Resolution No. 2026-3481

**Re: Sanford Fire Station #40
 COP #035 - Offsite Line Stop (RFI #95)**

TO: Honorable Mayor and Members of the City Commission
PREPARED BY: Ronnie McNeil, Fire Chief, CFO
SUBMITTED BY: Norton N. Bonaparte, Jr., ICMA-CM, City Manager
SUBJECT: Approval of Resolution No. 2026- 3481; Change Order Proposals

Requesting to approve Resolution No. 2026-3481 to amend the capital budget in the amount of \$381,157 for the procurement of the Change Order Proposals for Fire Department Station 40.

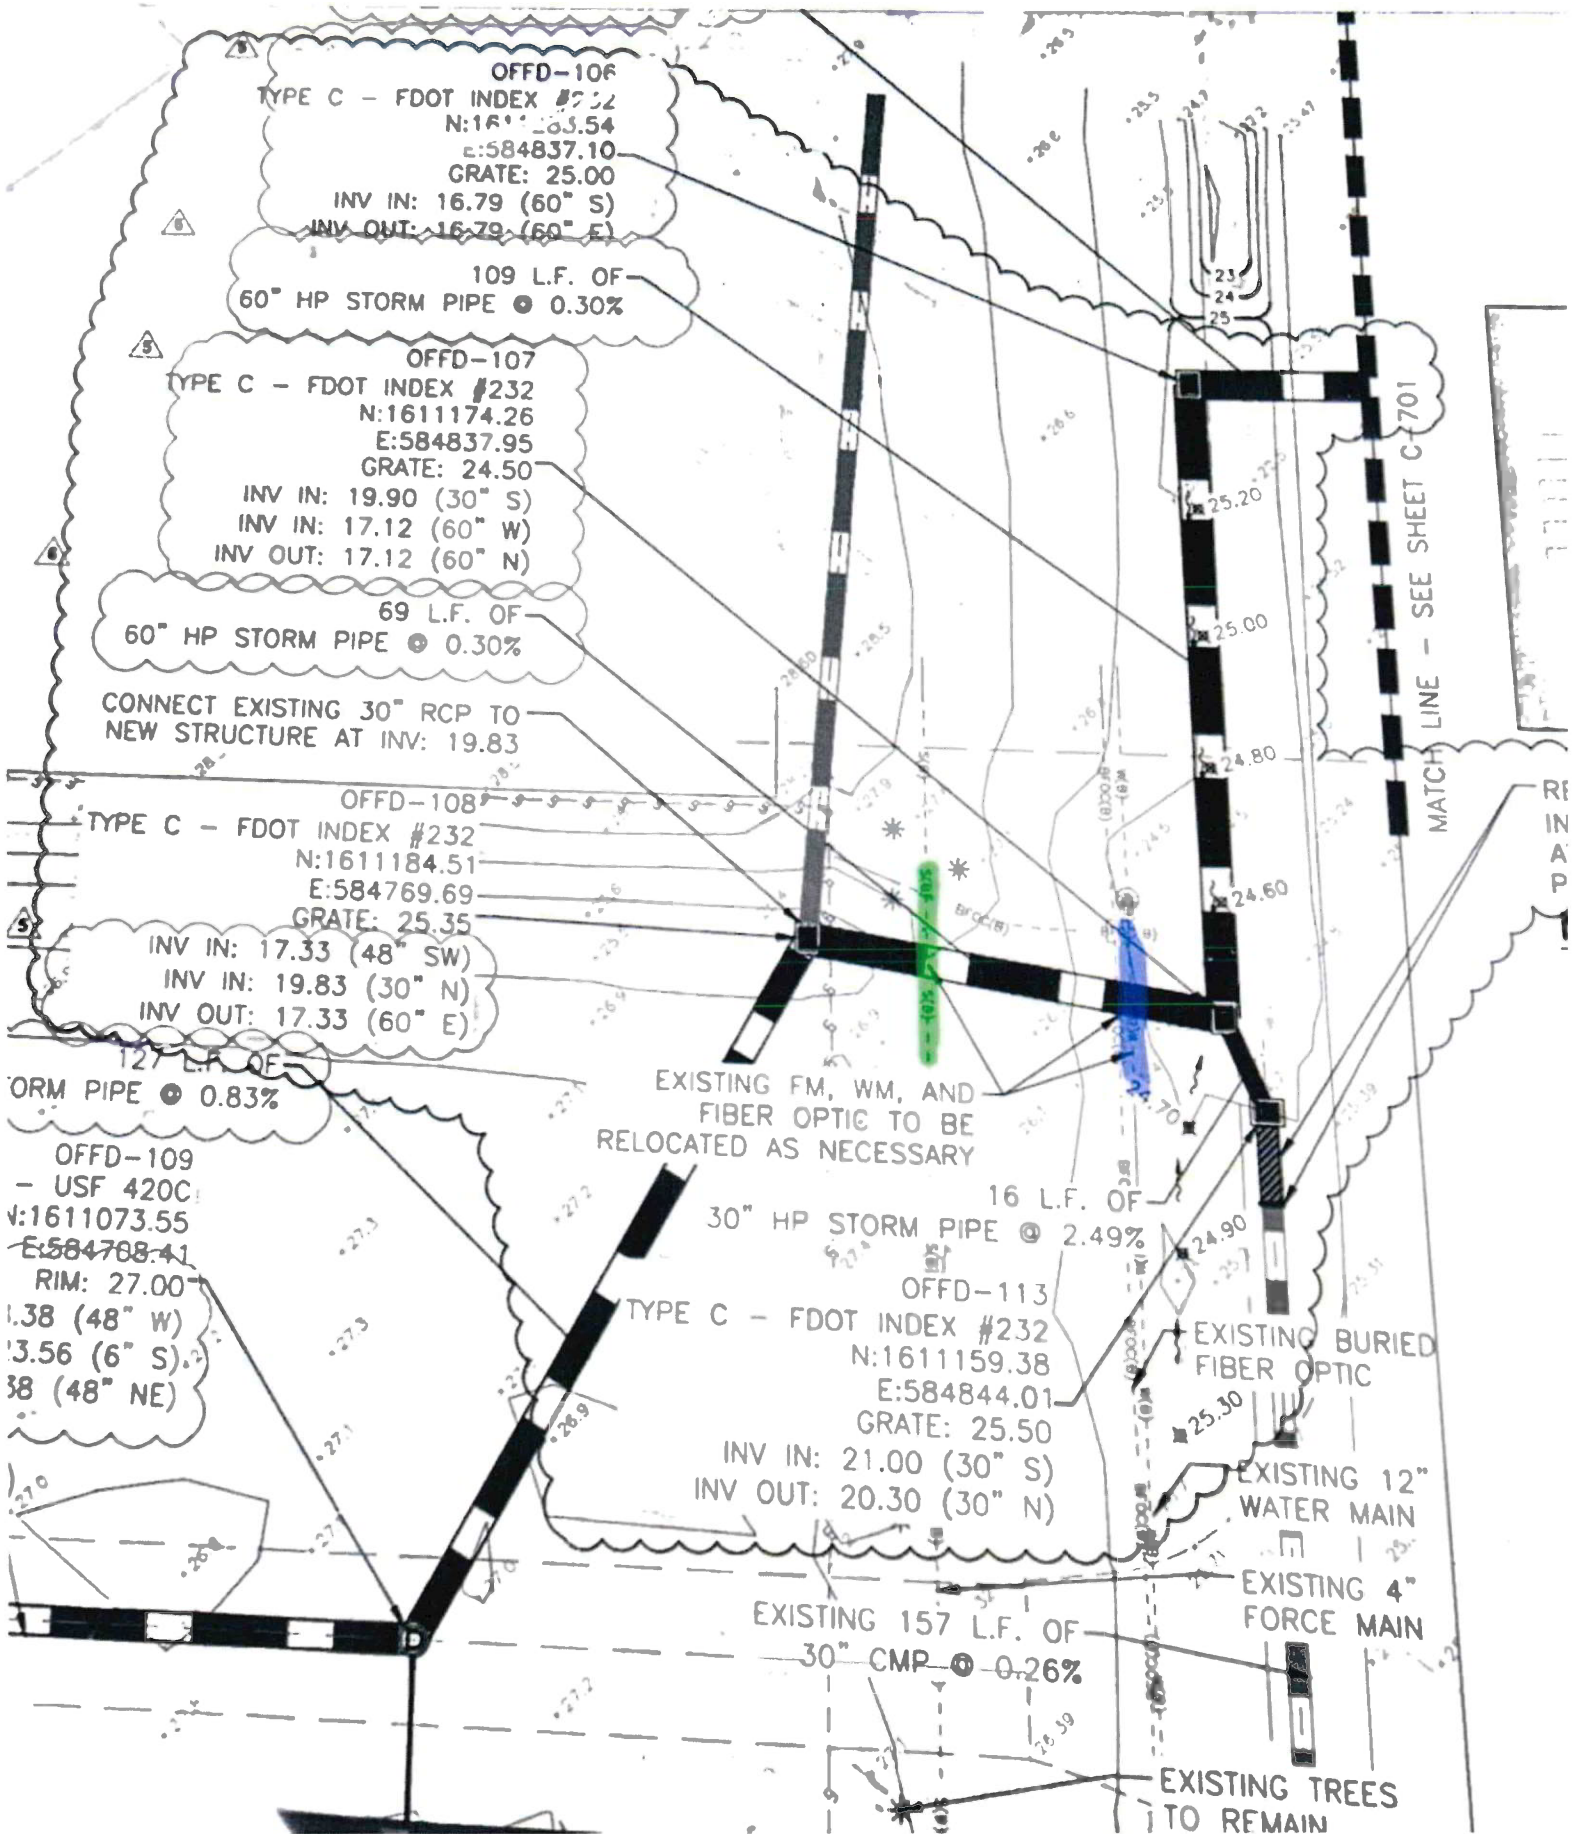
During a plan review, it was noted between structures OFFD-107 & OFFD-108 the new 60" storm pipe will conflict with an existing 12" water main and 6" force main. The field recommends deflecting under the aforementioned existing utility services, with the possibility of deflecting over the 6" force main.

Please see the site contractor's revised suggestion below as well as a revised markup.

The same separation provided between the FM and 60" ADS will allow for 3.10' of cover over the FM.

See attached mark up and elevations of the existing and proposed."

SUGGESTION: Hold the storm pipe elevations as per plan. If the water and forcemain need to be adjusted, do so in accordance with local jurisdiction separation requirements, at a minimum.

60" ADS Crossing Ex. 6" FM @ OFFD-107 to OFFD-108

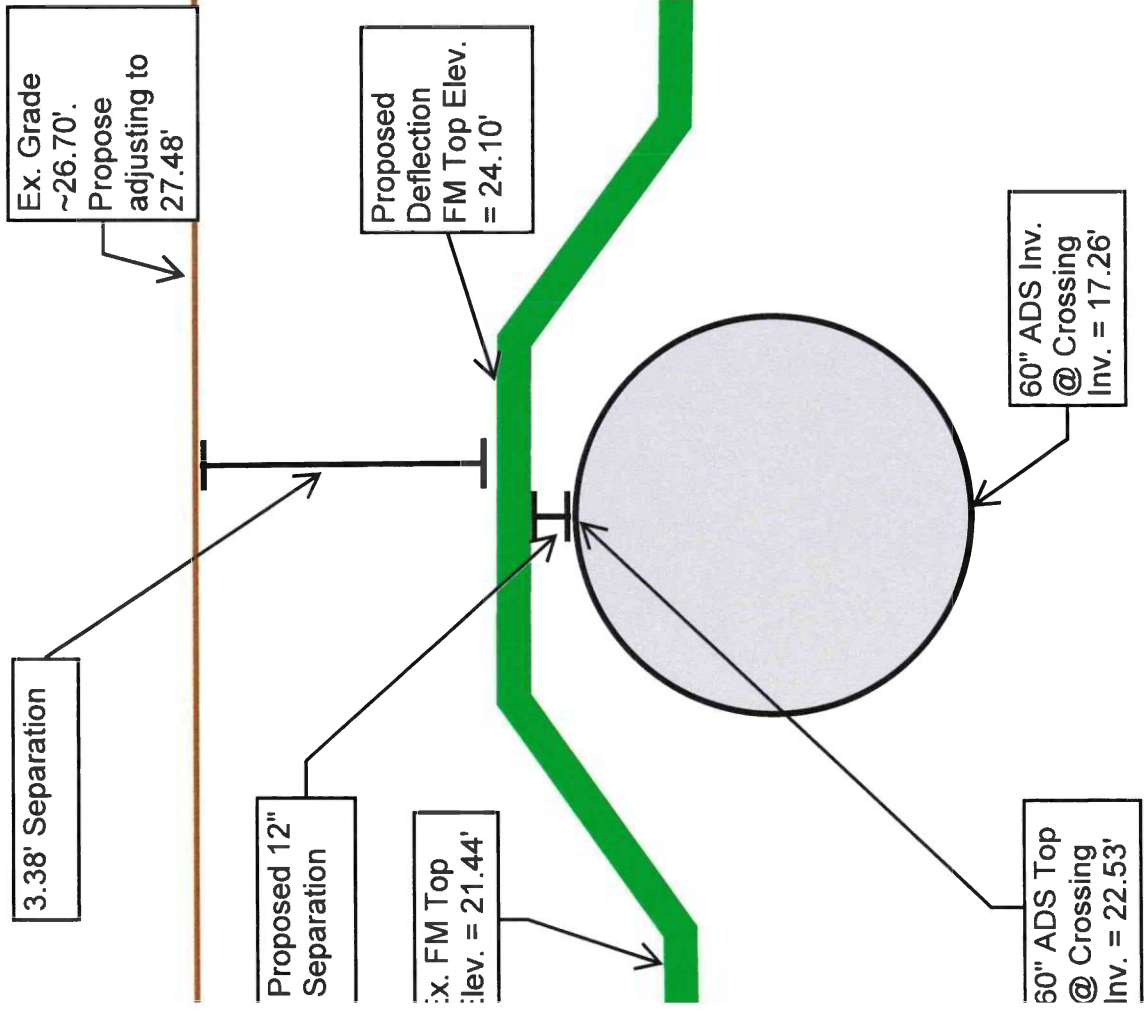
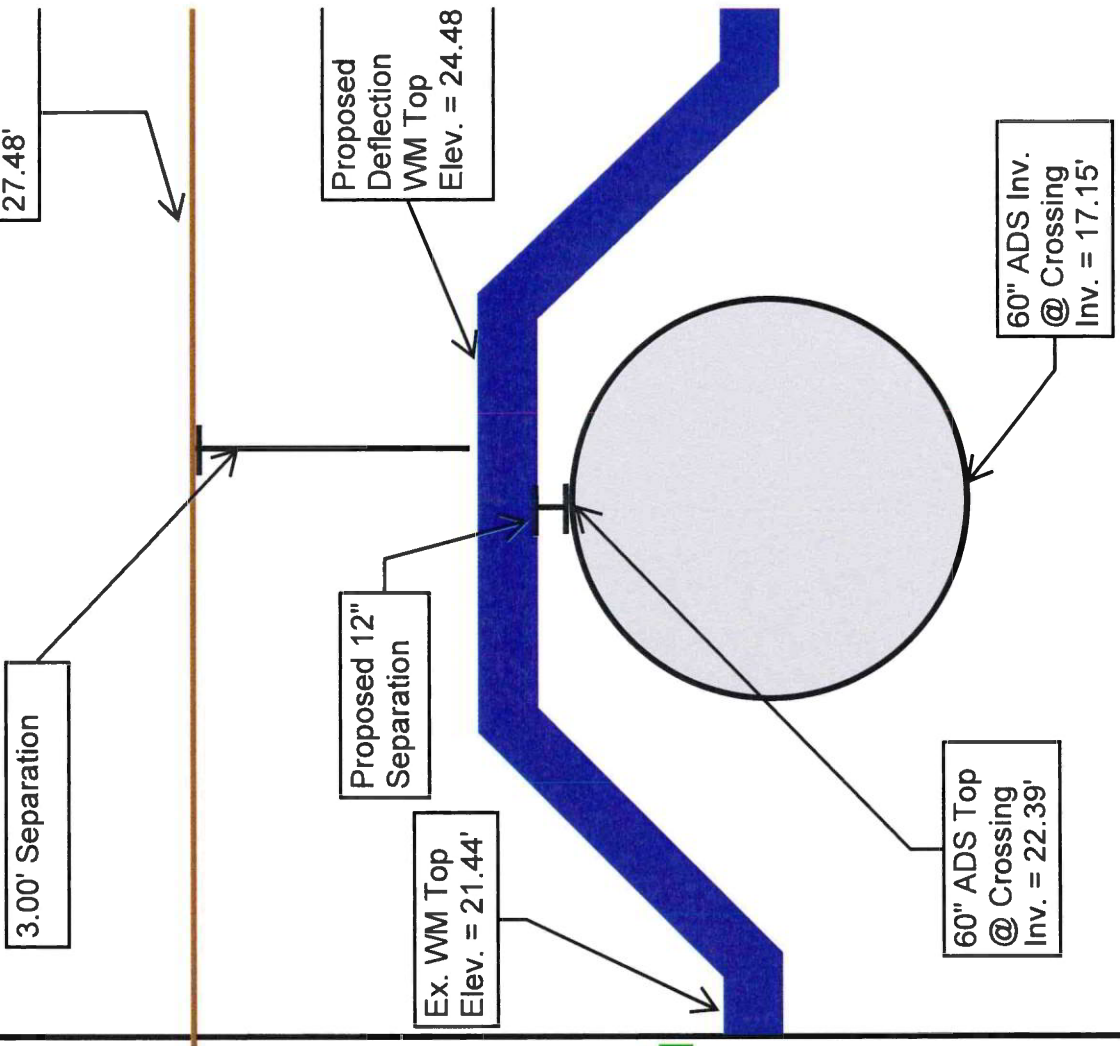
During a plan review, it was noted between structures OFFD-107 & OFFD-108 the new 60" storm pipe will conflict with an existing 12" water main and 6" force main. The field recommends deflecting under the aforementioned existing utility services, with the possibility of deflecting over the 6" force main.

Water main Elev. 12" 3.32

Below 20.44

Tap 21.44

Force main Elev. 6"

Below 21.19

Tap 21.79

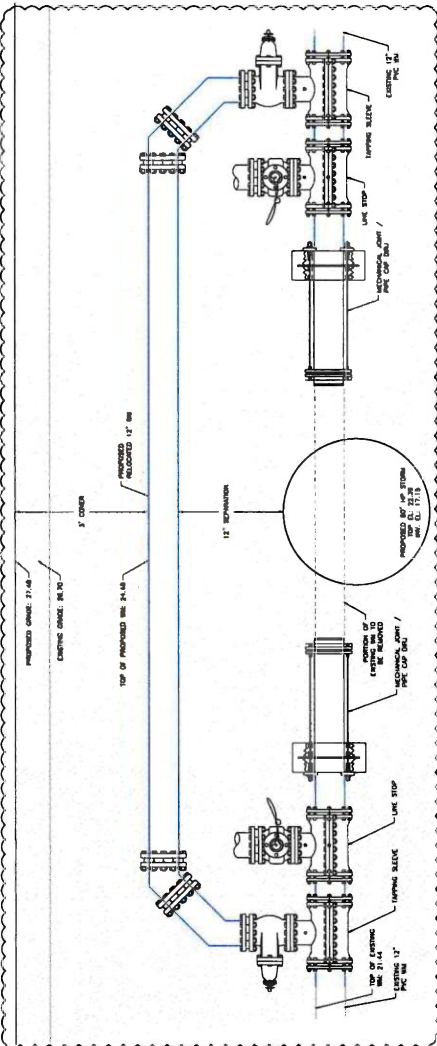
1. Line stops need to be added during the WM relocation. Please see the detail added to the "Documents" tab.

NOTES
 1. THIS METHOD IS TO ALLOW PRESSURIZED PIPES TO CROSS BELOW ANY PIPE WITH 18" VERTICAL SEPARATION AND MAINTAIN 30" MIN COVER TO FINISHED GRADE. THIS IS NOT COVER TO GRADE.
 2. ALL UTILITY LOCATIONS SHALL BE IDENTIFIED AND MARKED WITH PIPES AND RECORD PIPES OF THESE ARE OTHER PRESSURIZED PIPES IN QUESTION NOTIFY FOR BEFORE CROSSING IS COMPLETED.

Cohen Construction 4100 Saint John Parkway Sanford, FL 32771	Job Number	Job Name: Seminole Fire Station 40
	Designer: Lenny	Description: Elevations
	Date Started:	Revision Number: 0 of 0
Sheet: 1 of 14	Date:	04/06/26

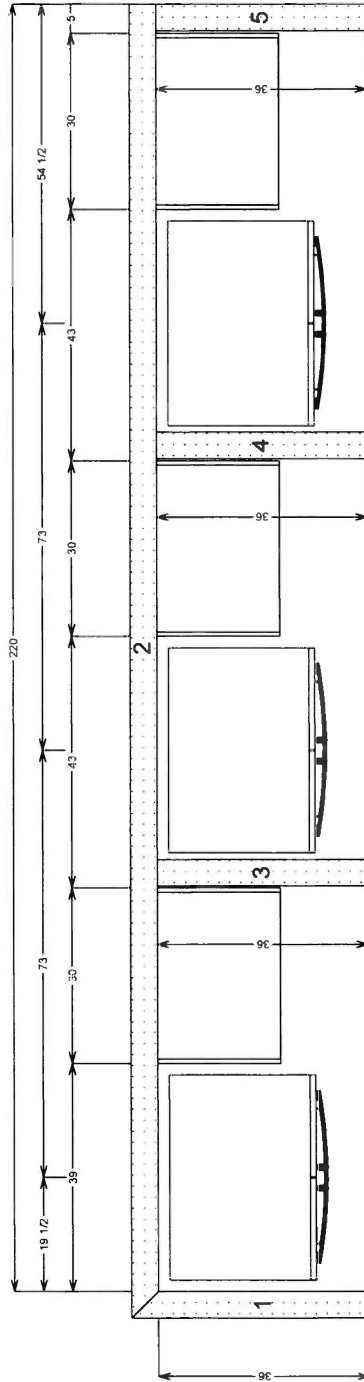
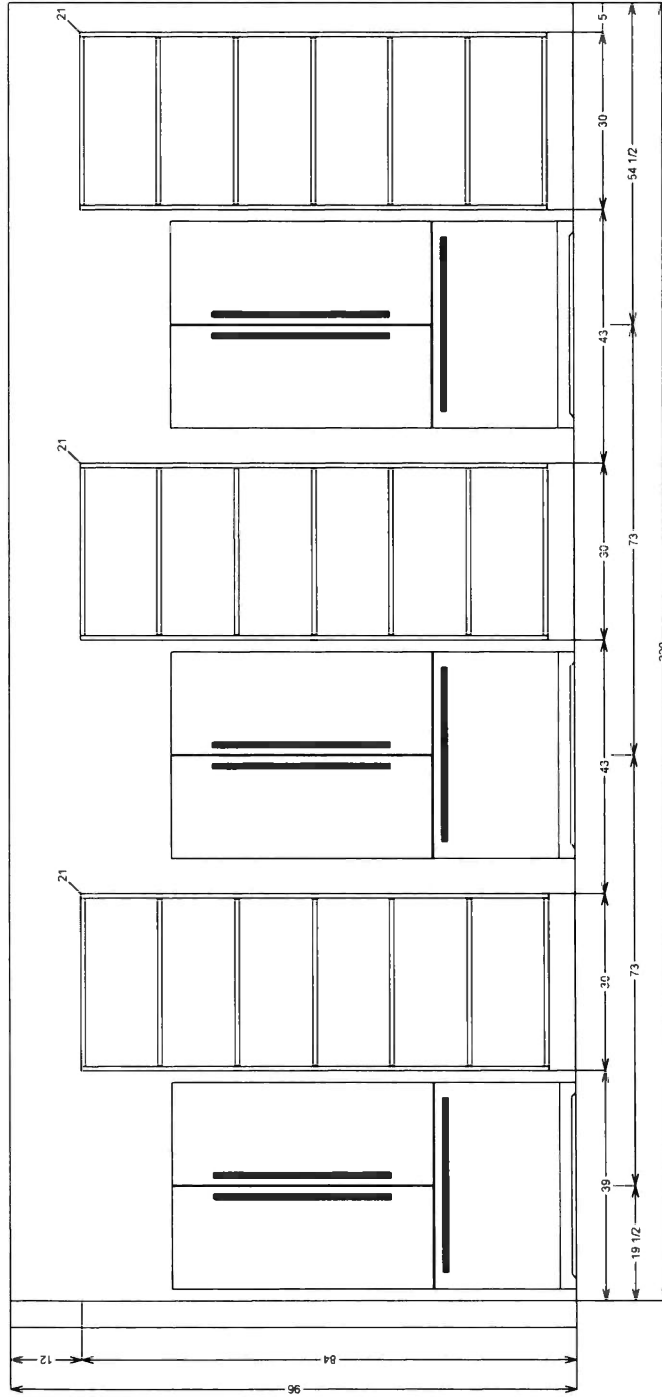
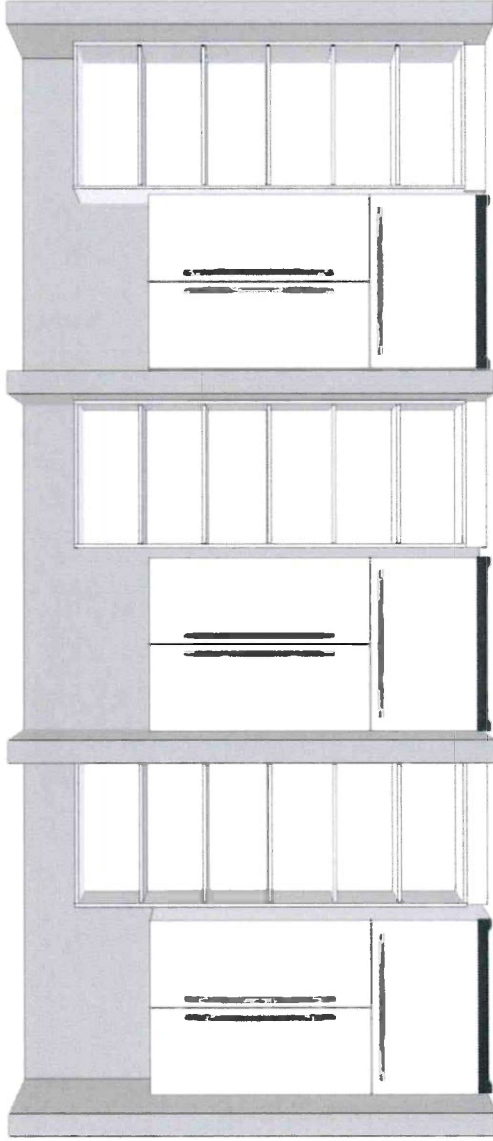
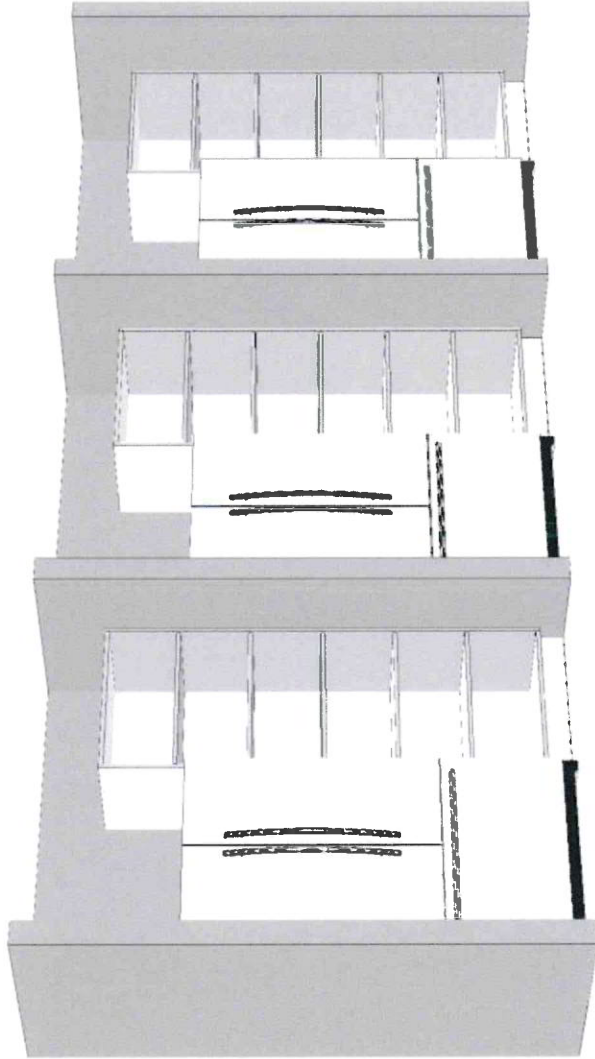
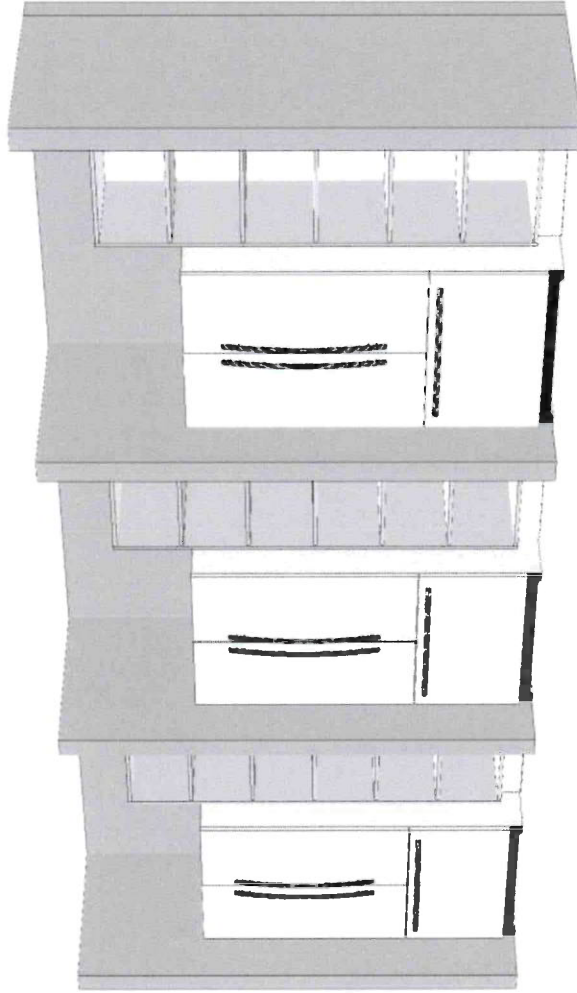
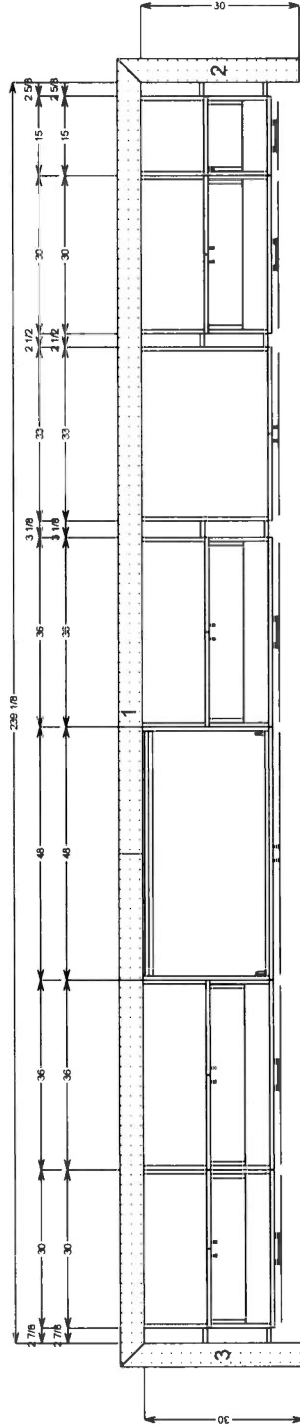
- Supply and install new kitchen cabinetry, shelving, and panels, including all required door and drawer pulls.
- All cabinetry shall be constructed of **100% ¾-inch all-weather board composite material.**
- Cabinet dimensions shall be custom-built to fit the existing kitchen layout as provided on the plans by Luna Group dated 3/20/26 and 8/28/24.

- Cabinet material to change to Starboard (color Black)
- Owner does not want knee or chase wall at back of island
- Owner requested dishwasher to left side of sink. (NOT shown.)
- Garbage disposal switch to be located in top of countertop by sink
- Island centered in room rather than aligned with sink
